Date: November 26, 2012

From: Steven Gorelick, PhD, NAE

Subject: Review of Proposed Basin Plan Amendment for Groundwater Beneficial Uses
at the Royal Mountain King Mine Site, Calaveras County
("Proposed Amendment")

This figure is for identification of sub-regions A - H, for ease of discussion in the text that provides review comments. The boundaries shown are not suggestions or recommendations.

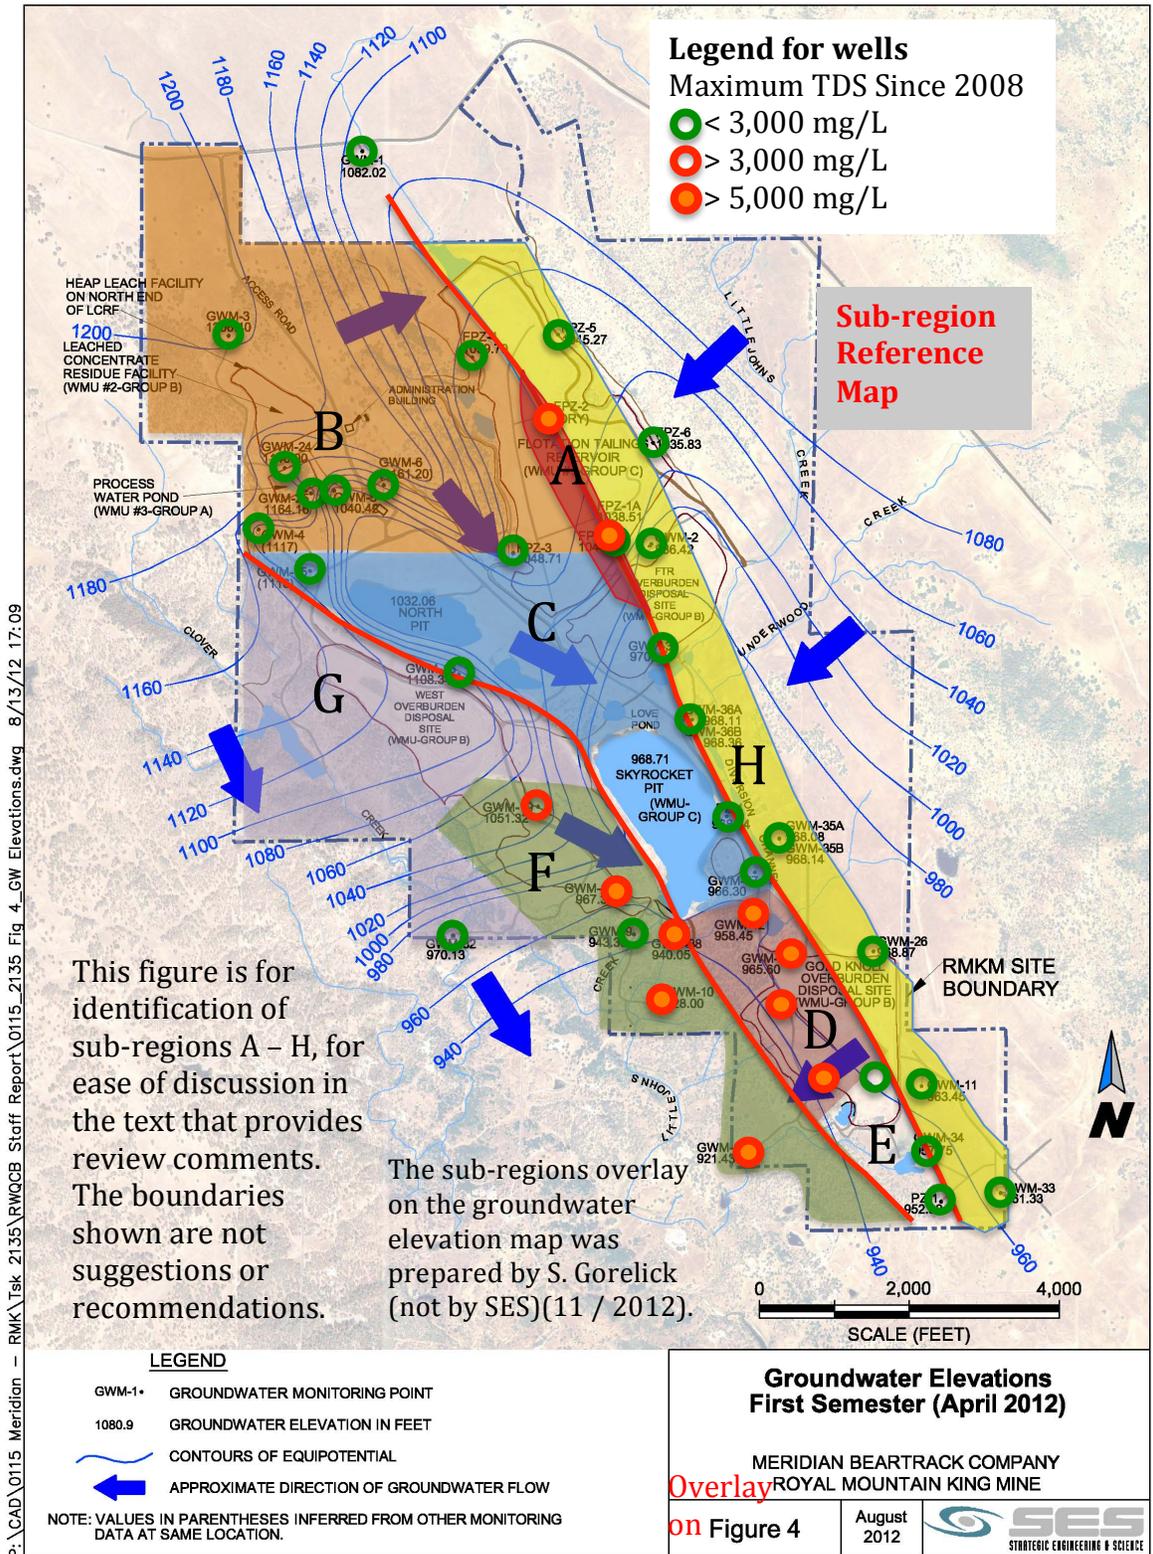
First consider sub-region “A” on the attached Figure. In the northern part of the Fault zone, FPZ-1B, showing TDS of 6,490 mg/L, lies on the trace of the Littlejohns Fault on the southern side of the flotation tailings reservoir. High TDS likely occurs to the north as far as inactive monitoring location FPZ-2, also on the fault trace (at the northern part of the flotation tailings reservoir). This well showed TDS concentrations in excess of 10,000 mg/L in 2008-2009 but has been indicated as “dry” since then (and is therefore not included in the attached summary table showing groundwater TDS of active

Monitoring data suggest that the higher salinity area (sub-region “A”) does not extend westward. First, there is no indication of elevated TDS at FPZ-3 (TDS < 500 mg/L), located about 1,500 feet to the west of FPZ-1, or farther west to GWM-16, at the western margin of the Fault zone (average TDS ~700 mg/L). Second, groundwater flow is toward the southeast in this area, transporting lower TDS groundwater toward the fault. No other areas in the northern part of the Fault zone region show TDS concentrations meeting the MUN de-designation criterion. Therefore, inclusion of the entire northern area of the Fault zone in the MUN de-designation is not scientifically justified based on the existing TDS data, the direction of groundwater flow, and consideration of the hydrogeologic system.

Next, consider MUN de-designation in the northwestern sub-region of the Site; this area, indicated by “B” on the attached Figure, includes the northern part of the Fault zone and coincides with the area proposed for a site-specific TDS objective of 5,000 mg/L to support livestock watering. This sub-region appears to include FPZ-1, already discussed, which shows high TDS on the Littlejohns Fault. FPZ-1B (but not FPZ-1A 17 feet deeper) is the only currently monitored well in this sub-region with TDS exceeding 3,000 mg/L; samples from the other eight wells in the sub-region (GWM-3, GWM-4, GWM-5, GWM-6, GWM-24, GWM-25, FPZ-3, FPZ-4) do not indicate that the MUN de-designation criterion is met (see attached data summary table). Measured TDS in these eight wells averages ~700 mg/L, with five wells showing TDS of 600 mg/L or less. Since 2008, TDS concentrations at all eight locations have not exceeded 1,600 mg/L. The average of the maximum TDS values is 991 mg/L. Data suggest that this northwestern sub-region of the Site (Fault zone) does not meet the TDS threshold of 3,000 mg/L necessary for MUN de-designation, with the exception of the vicinity of FPZ-1, which appears to indicate a local area of contamination along the Littlejohns Fault as discussed above.

No groundwater monitoring data for TDS are available for the central area directly to the south of the northwestern sub-region “B” (downgradient of FPZ-3 and upgradient of Skyrocket Pit) in the northern part of the area indicated by “C” on the attached Figure. However, this area, apart from a narrow region along the Littlejohns Fault, likely does not meet the 3,000 mg/L MUN de-designation criterion for the following reasons:

In the southern part of the MUN de-designation area (shown as sub-region “D” on the attached Figure), neighboring monitoring wells GWM-12 and GWM-21 show TDS values substantially and consistently in excess of 3,000 mg/L. Elevated TDS values at GK-1 and GK-2, just south of GWM-12 and GWM-21, support the existence of a high-salinity zone in this southern sub-region of the Fault zone area. Sub-region “D” can be delineated with existing monitoring data. Monitoring well GWM-37 directly to the north of and near GWM-12 shows TDS of less than 650 mg/L, and wells GWM-34 and PZ-1 to the south in the Fault zone sub-region show TDS less than 500 mg/L (area “E” on the attached Figure). The significantly lower TDS values at these locations suggests that the very high TDS sub-region in the southern Fault zone area is likely contained between monitoring wells GWM-37 to the north and GWM-34 to the south. The highly saline groundwater in this southern sub-region would be expected to migrate to the southwest, where TDS values of ~9,000 mg/L occur at GWM-31 in the Phyllite zone. A southern high TDS sub-region in the Fault zone meeting the MUN de-designation criterion would be scientifically justified.

- 1) In the vicinity of FPZ-1B, along a (narrow) portion of the Littlejohns Fault, subregion “A” (see attached Figure): The contaminated area does not appear to extend as far south as MW-30, where TDS concentrations have not exceeded 3,000 mg/L (based on data since 2008) or as far west as FPZ-3, where concentrations have been less than 400 mg/L for ~4 years. The narrow zone likely extends north under the flotation tailings reservoir along the fault.
- 2) In the highly saline southern sub-region “D” downgradient of GWM-37 but north of sub-region “E” (see attached Figure).

MUN de-designation in the Phyllite zone: Of the seven monitoring wells in this region, four show elevated TDS concentrations in excess of 3,000 mg/L (area shown as “F” in the attached Figure). The average TDS concentration exceeds 9,000 mg/L. GWM-19 shows a TDS of 2,190 mg/L in the most recent sample, but samples from 2009, 2010, and 2011 have exceeded 3,000 mg/L. Although GWM-9 has not shown TDS exceeding 3,000 mg/L since 2008, values above this threshold were observed in 2000 and before. GWM-32 to the far west is anomalous in this zone, with TDS of ~400 mg/L, indicating local low-salinity conditions; it is possible that the low TDS could reflect interactions with nearby Clover Creek and/or better water quality associated with the local area of green chlorite schist (SES, 2006, Figure 2.1). Because there are no monitoring wells upgradient of GWM-19 (region “G” in attachment Figure 1) within the Phyllite zone, it remains uncertain whether the entire Phyllite zone meets the MUN de-designation criterion. However, based on the hydrogeochemistry of this geologic unit, it is possible that high TDS values exist over much of the Phyllite zone (CVRWQCB, 2003). With the exception of too few monitoring wells to define the measured upgradient extent of the region having TDS exceeding 3,000 mg/L in the Phyllite zone and the region to the southwest where TDS is low, there is a reasonable scientific basis for its inclusion (at least in part) in the MUN de-designation.

In the Fault zone, as noted above, TDS concentrations do not exceed 3,000 mg/L over much of the zone, and MUN de-designation is not scientifically justified throughout. As such, AGR de-designation is also unjustified in the same region. AGR de-designation is justified in the high TDS sub-regions in the vicinity of FPZ-1B (area “A” on the attached Figure) and downgradient of GWM-37 (area “D” on the attached Figure).

- Central to the Proposed Amendment is the determination of the boundaries for proposed MUN and AGR de-designation areas and the AGR site-specific objective region. To be scientifically defensible, the establishment of these boundaries must be based primarily on water quality (i.e., TDS) historical data, sound interpretation of groundwater flow directions, and hydrogeologic as well as zonal hydrogeochemical characteristics. The following points refer to sub-regions “A” through “H” whose locations, but not precise boundaries, are shown on the attached Figure.

- Based solely on the TDS criterion of 3,000 mg/L, MUN de-designation is potentially supported in small, narrow sub-region “A” along the Littlejohns Fault in the

- MUN de-designation is scientifically supported in Phyllite zone sub-region “F” based on monitored TDS values exceeding 3,000 mg/L with the caveat that the northwestern sub-region “G” of the zone has not been monitored, and one area is known to have low TDS. Hydrogeochemistry of the region suggests that much of the Phyllite zone has high TDS values.

- The AGR de-designation criterion is not met over the area proposed. With the exception of sub-regions “A” and “D” in the Fault zone, and “F” and perhaps “G” in the Phyllite zone, TDS measurements do not indicate values are above 5,000 mg/L.

- Data do not support the northwestern sub-region “B” target for an AGR site-specific TDS objective of 5,000 mg/L. With the exception of sub-region “A” along the Littlejohns Fault, TDS concentrations average ~700 mg/L in sub-region “B” and maximum concentrations range from 360 to 1,600 mg/L. (MUN de-designation, which is more restrictive, also is not scientifically sound in this area.)
